Sun Valley Area Drainage Master Plan

TECHNICAL DATA NOTEBOOK

Approximate Zone A Floodplain Delineation Study of White Tank

Fans 17, 18, and 19

PLATE 1
WATERSHED MAP

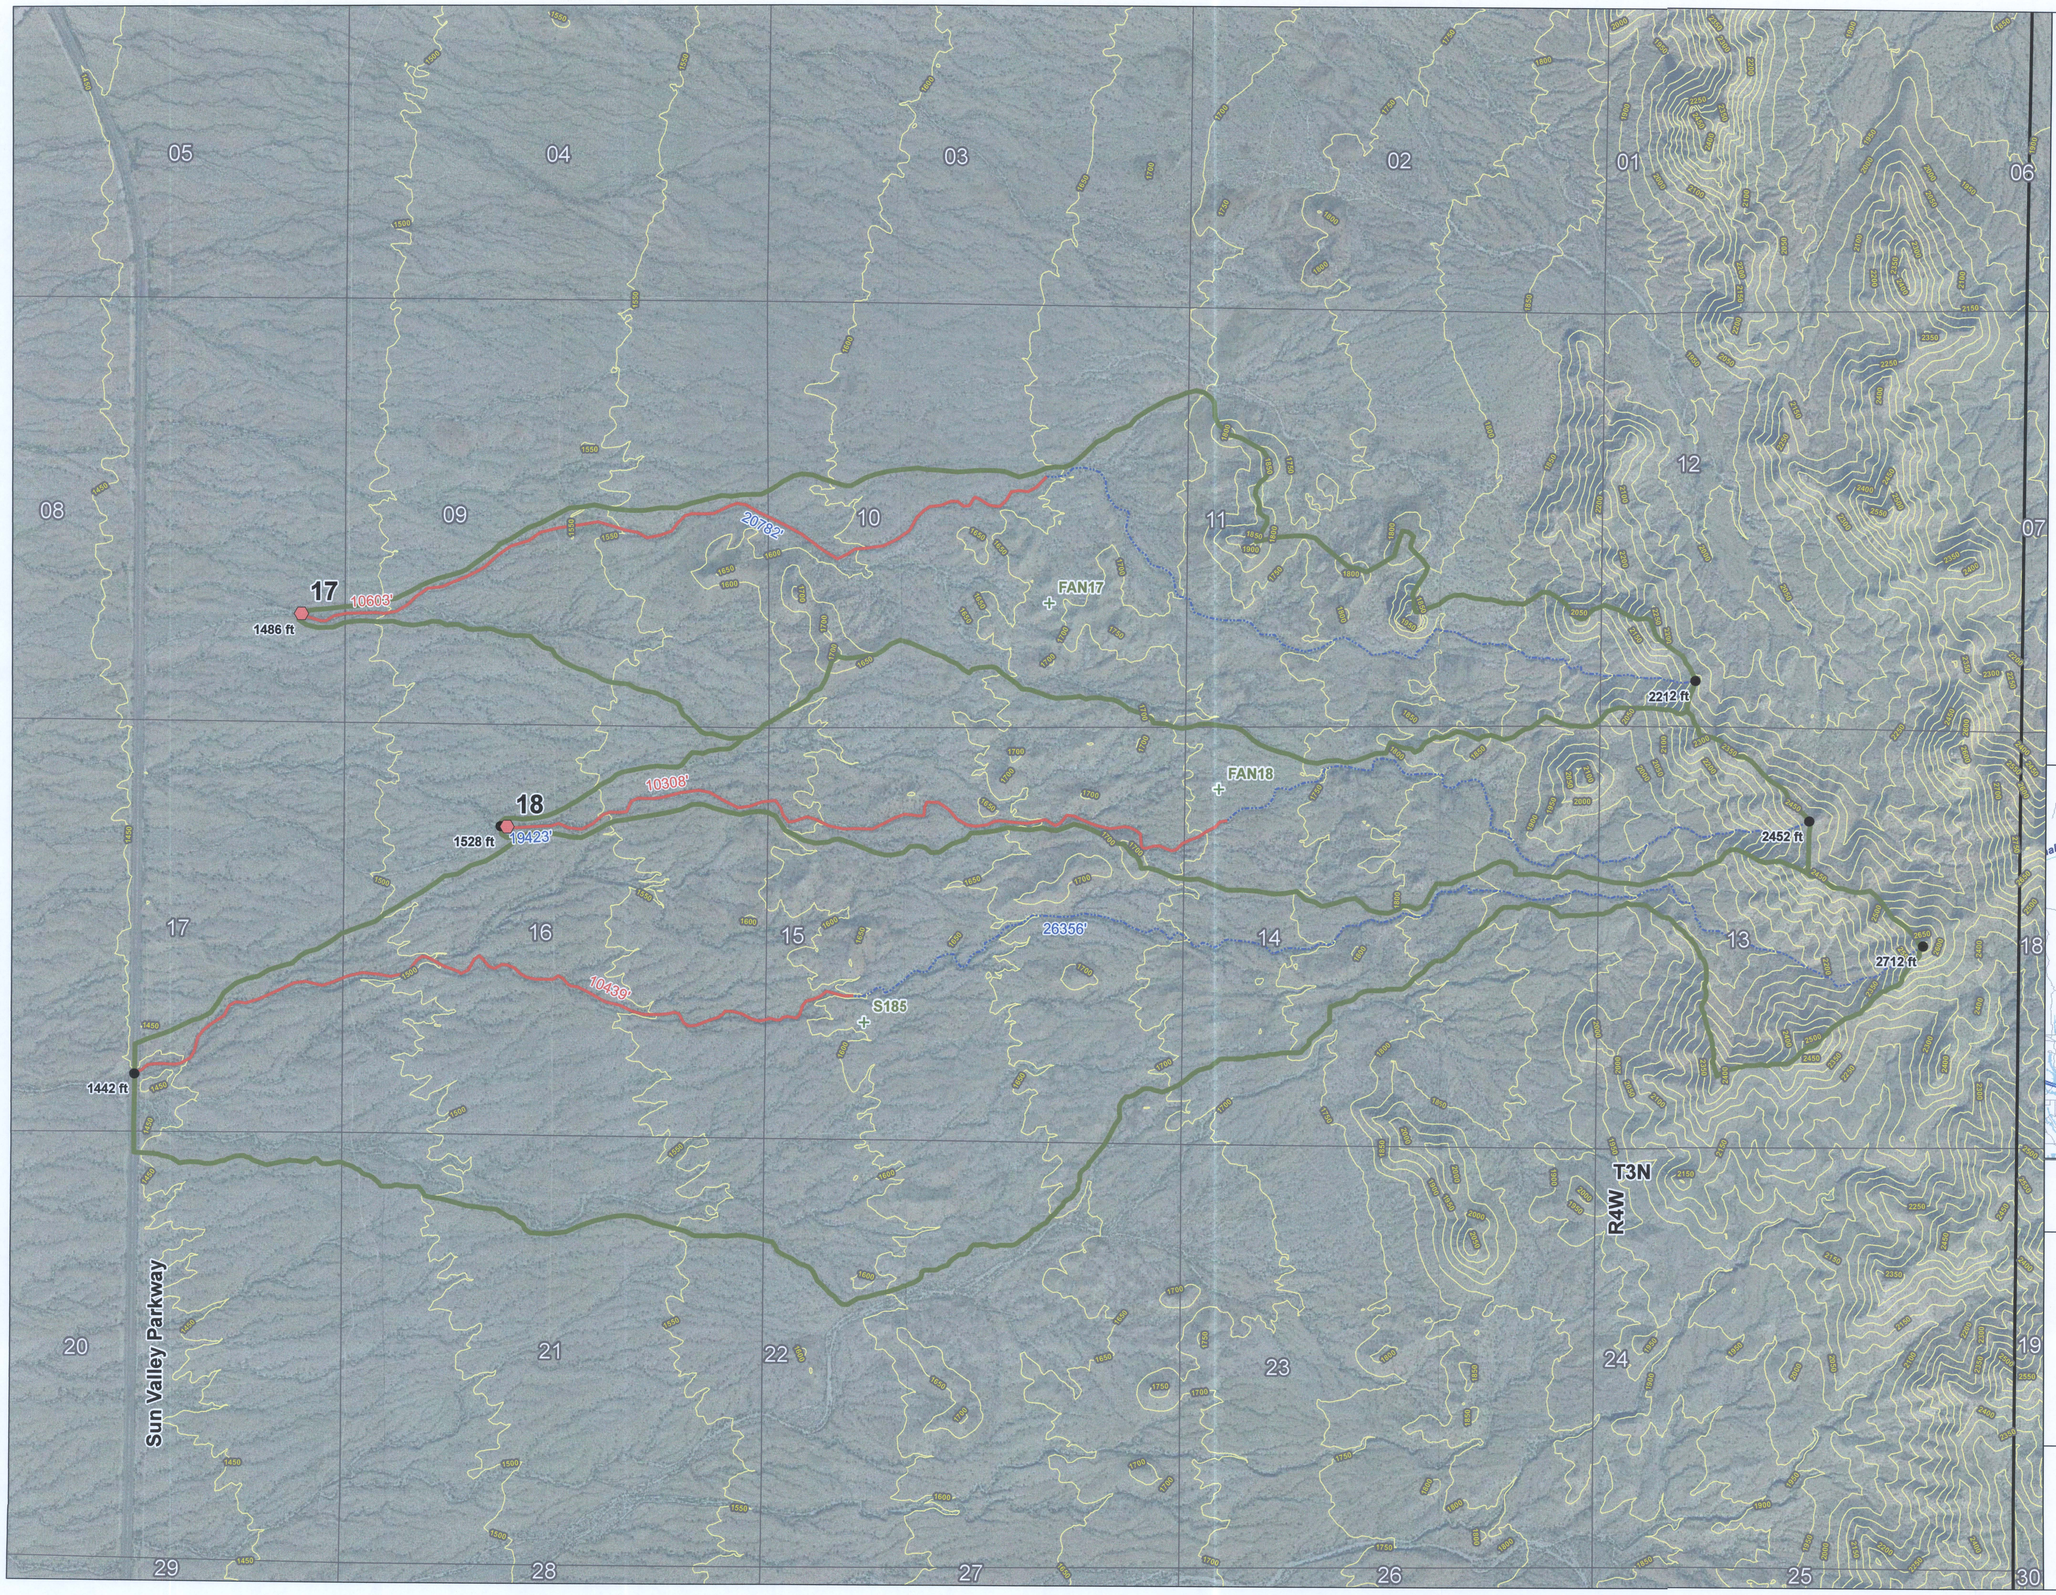
6. Plate 1 – Add title Watershed Map, add the ft symbol to the top and bottom elevations, recommend changing to black and white map due to reproduction issues.
   JEF Response: Done. The symbology has been revised so all features will be discernable when reproduced in black and white.
